## **Report on the status of work on the issue of electro-hydraulic systems, (ECE/TRANS/WP29/GRRF/2013/29)**

Based on the informal paper GRRF-76-24e.pdf presented on the 76.GRRF and a mandate from GRRF after the subsequent discussion an ad hoc group on the issue of annex 14 to R13 was founded. The first and so far the only session was on April 8. and 9. Under participation of industry, OICA, Netherlands, Japan and Germany. The text below reflects the status after that session and though some issues could be clarified (telltale, connector) it still leaves some questions unanswered (residual voltage, testing voltage, enabling of trailer braking via stop light signal or combination deceleration alone (1.3 and 2.5)). A few comments to those questions are at hand meanwhile but not worked in the text below. In the course of the discussion it was pointed out that the intended technology to be used requires energy reservoirs on the trailer and as such may differ from the technology that the current annex 14 is based on thus raising safety issues that have been already resolved in the field of O3/O4-trailers. Therefore it seemed appropriate to rely on some principle requirements to the lat

**Annex 14 - Appendix**  
**Compatibility of the braking rate of the trailer and the**  
**mean fully developed deceleration of the tractor/trailer**  
**combination (trailer laden and unladen)**

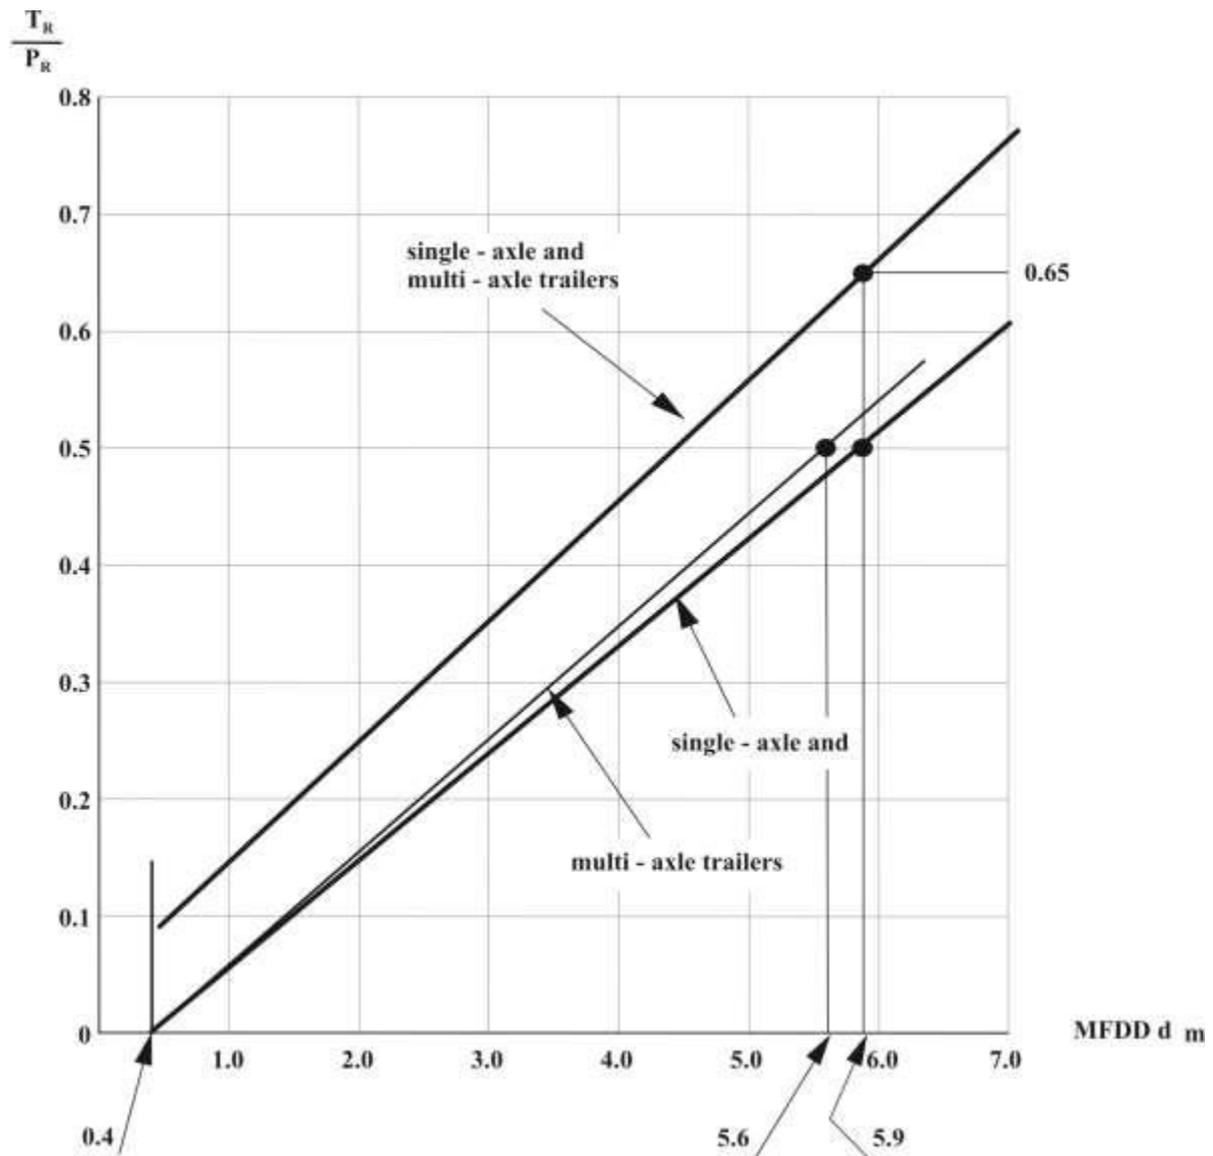
*Annex 14, Appendix text in the diagram amend to read:*

**In the diagram the terms “centre-axle trailer” and “semi-trailer” shall be used instead of “single-axle trailer”. The term “full trailer” shall be used instead of “multi-axle trailer”**

*For clarification, in the past terms as multi axle trailer and single axle trailer were use. In the meantime these terms are replaced by full trailer, centre-axle trailer and semi-trailer.*

### **Comment on the appendix to annex 14 with regard to multi axle trailers i.e. full trailers**

1. In the course of the debate around annex 14 an issue was also the allowable drawbar forces. The appendix allows drawbar forces that are comparable to those for multi axle overrun braked trailers. The documents 2004/10 and 2004/11 differ in the wording of 5.2.2.2 as to the applicability of annex 14 for full trailers resulting in the current state of 5.2.2.2 which implies the use of annex 14 to full trailers.
2. Allowable drawbar forces of full trailer are smaller than those of centre axle trailers both in annex 12 and annex 14 which suggests that the regulation had already made up for the situation of drawbar forces in case of full trailers.
